# Service Bulletin

**Subject:** Pop Or Scrape Noise When Liftgate Or Glass Is Opened Or Power Liftgate Reverses

**Models:** 2015 Chevrolet Suburban and Tahoe  
2015 GMC Yukon and Yukon XL  
Built prior to 3/11/14

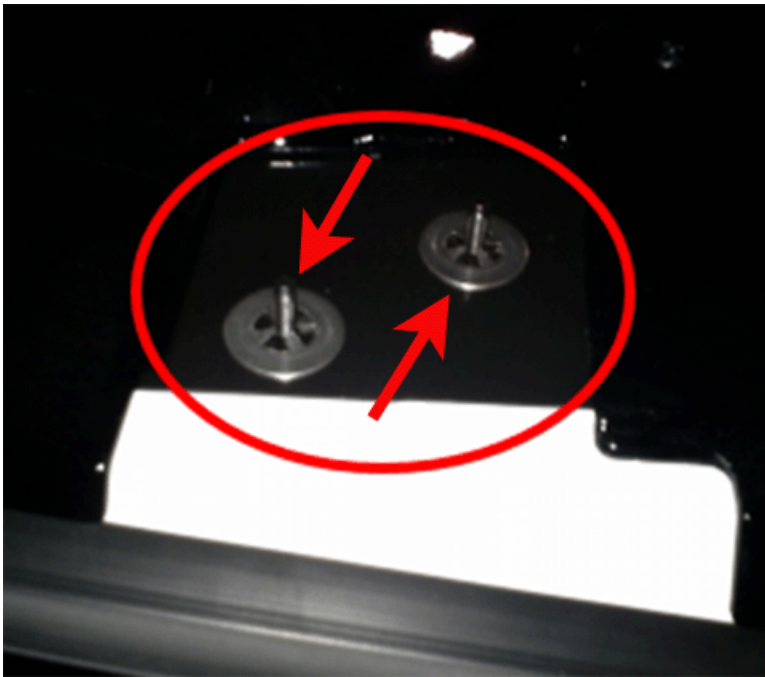
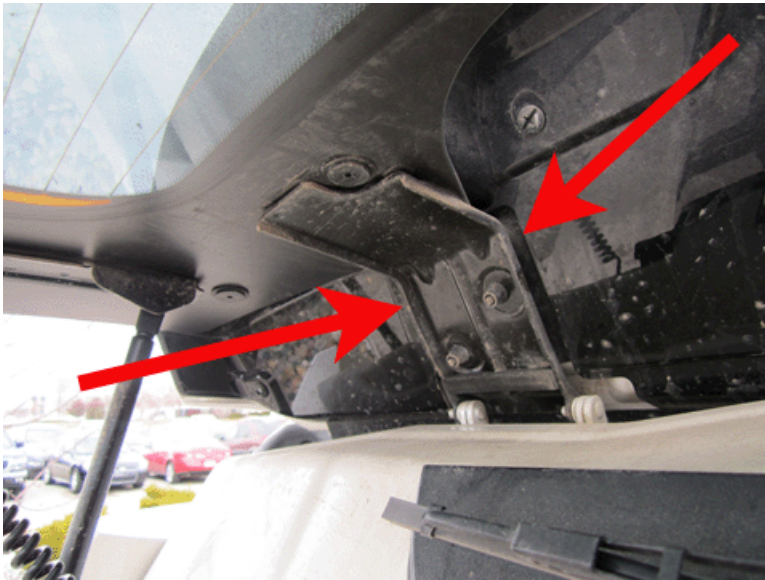
Some owners may comment when the lift gate or lift glass is opened, there is a pop or scrape noise. In some cases, the power lift gate (if equipped) may reverse when opening.

This concern could be caused by the lift gate spoiler contacting the roof and is more noticeable with thermal expansion caused by the sun.

1. Some trucks are equipped with shims located between the left hinge and spoiler, as shown below. If shims are present, remove them and reassemble. The complete spoiler does not need to be removed to access the shims.  
After removing all of the spoiler attachment fasteners, close the liftglass and lift up on the spoiler to inspect for shims and remove them if they are present. Retest for the concern by parking the truck in the sun for a few hours and see if this corrected the concern. If the concern is not corrected, continue to step 2.

2. If removing the shims does not correct the concern, the spoiler will need to be replaced.
